**AMENDMENT NO. 6 (02 / 2019)**

**AIS-029 / 2004**

**Survival Space for the Protection of the Occupants  
of the Cab of a Commercial Vehicle**

**AUTOMOTIVE INDUSTRY STANDARD**

**(Fiftieth –percentile Male Body)**

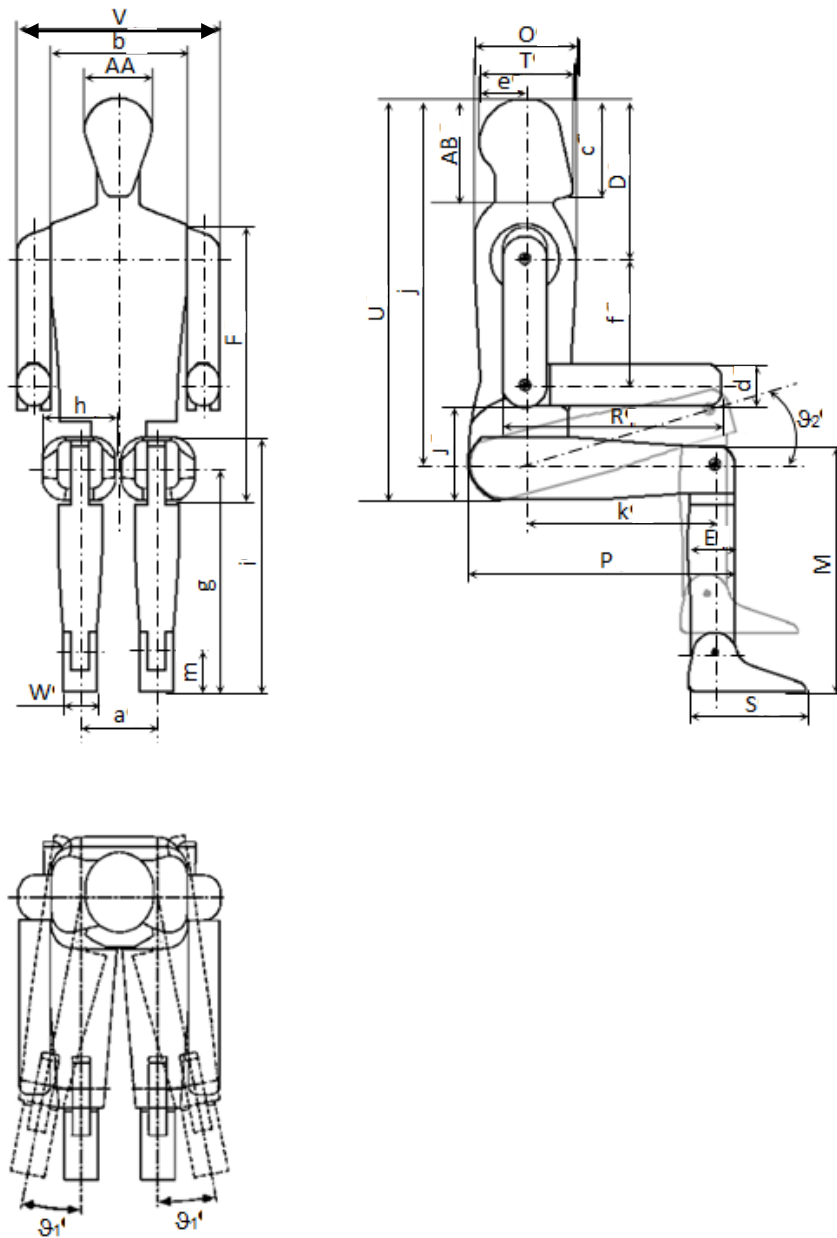
1.0 Page No. 9/15, Annex: 2, Figure (Fiftieth - Percentile Male Body)

Substitute following figure for existing figure

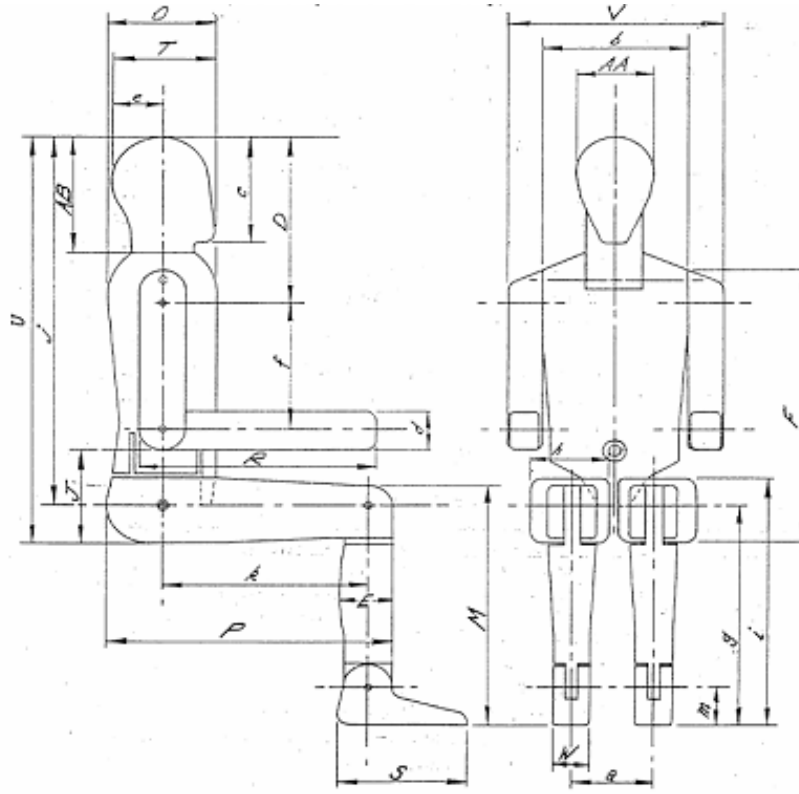
1.0 Page No. 9/15, Annex : 2, Figure (Fiftieth - Percentile Male Body)  
Substitute figure given below for existing figure.
